Amendments to the Drawings

U.S. Appln. No.: 10/557,826
Atty. Docket No.: P70779US0

Fig. 1

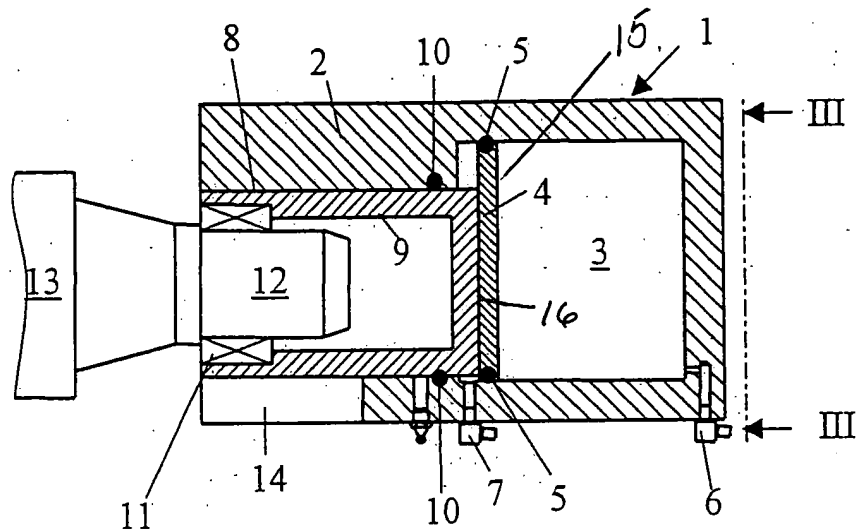
In accordance with 37 CFR § 1.121(d)(1), attached hereto is one annotated sheet depicting changes made to drawing Figures 1 and 2. The attached Figures 1 and 2 have been amended as required by the examiner to add the lead lines and reference numbers associated with the boundary surface 15 and connecting point 16 features.

Also attached hereto is one replacement sheet of drawings, incorporating the changes made to Figures 1 and 2, which replaces the drawing figures originally submitted with the application.
